SUBJECT: INDEPENDENT QUALITY REVIEW GROUP COMMENTS ON THE ABB-COMBUSTION  
ENGINEERING (ABB-CE) SYSTEM 80+ CERTIFIED DESIGN MATERIAL (CDM) AND  
ABB-CE STANDARD SAFETY ANALYSIS REPORT (CESSAR-DC)

An Independent Quality Review Group has reviewed the CDM and the CESSAR-DC, and provided their comments to the staff inspections, tests, analyses, and acceptance criteria (ITAAC) task groups. The ITAAC task groups have reviewed the comments, and those that require action by ABB-CE are contained in the enclosure.

FIGURE 2.9.1-1  
LIQUID WASTE MANAGEMENT SYSTEM

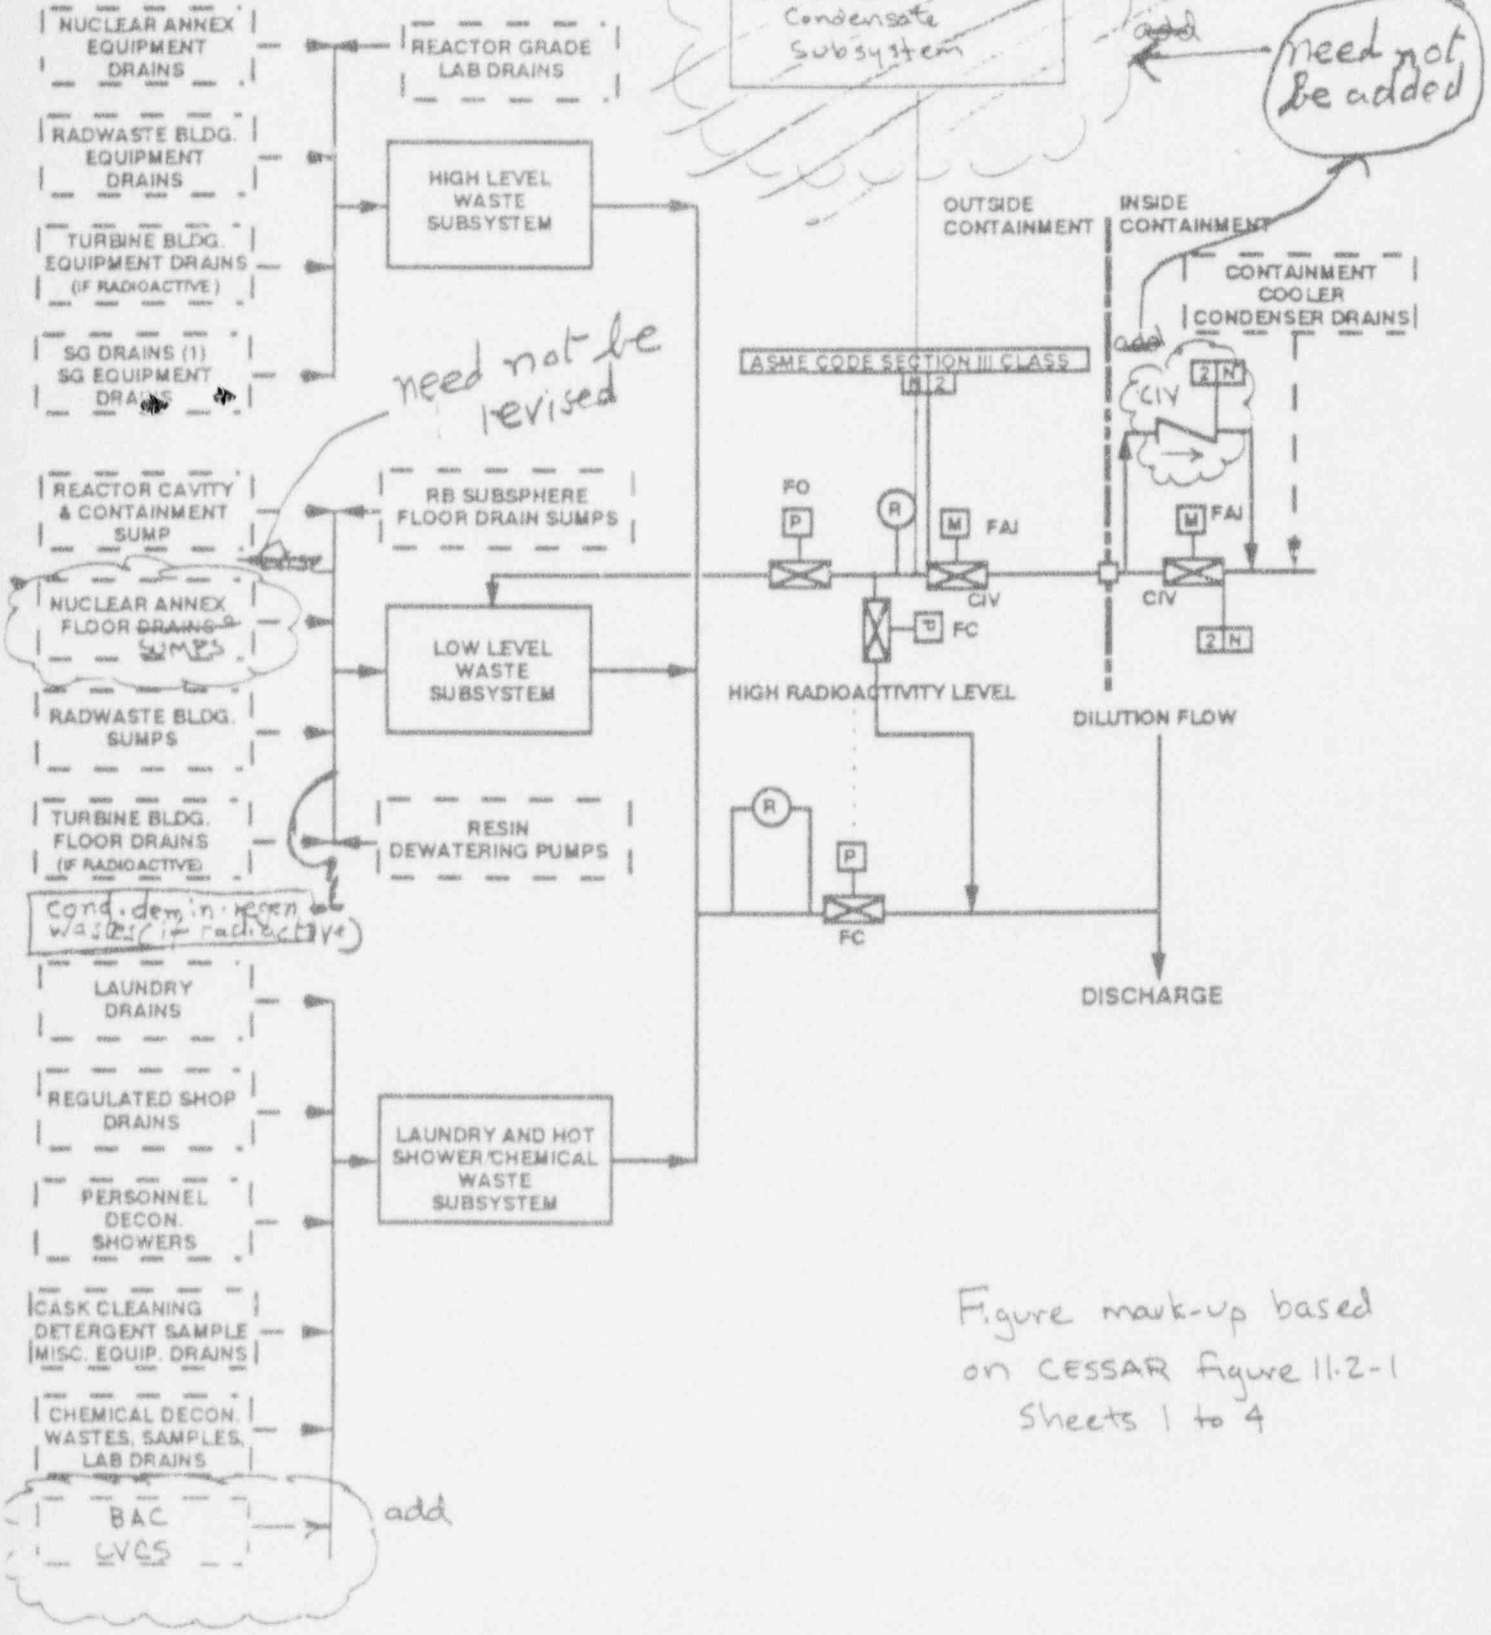
No.	Comments	Cat.	Resolution
1	Mark-up for design description and ITAAC is attached. <i>Partial agreement</i>	1	Agree with design description and ITAAC table 2.9.1-1 mark-up. Marked-up further ITAAC design description. Agree only with the mark-up of ITAAC Fig. 2.9.1-1. Added one input to low level waste subsystem (for explanation see below)
2	Editorial SSAR mark-up attached.	3	Agree with editorial SSAR mark-up. Added one more editorial SSAR mark-up. ABB-CE has previously indicated that the added mark-up relating to laundry hot shower wastes will be incorporated in the CESSA-DC revision.
<u>Explanation of Resolution of Comment 1</u>			
<p>1. Containment cooler condenser drains figure shows that these can be either by the low level waste subsystem. Also, the low motor operated containment isolation valve is not credited as</p>			<p>are already shown in Fig. 2.9.1-1. The figure shows that these go through isolation valves. So there is no need to a containment isolation valve. So</p>

Figure mark-up based on CESSAR figure 11.2-1 Sheets 1 to 4
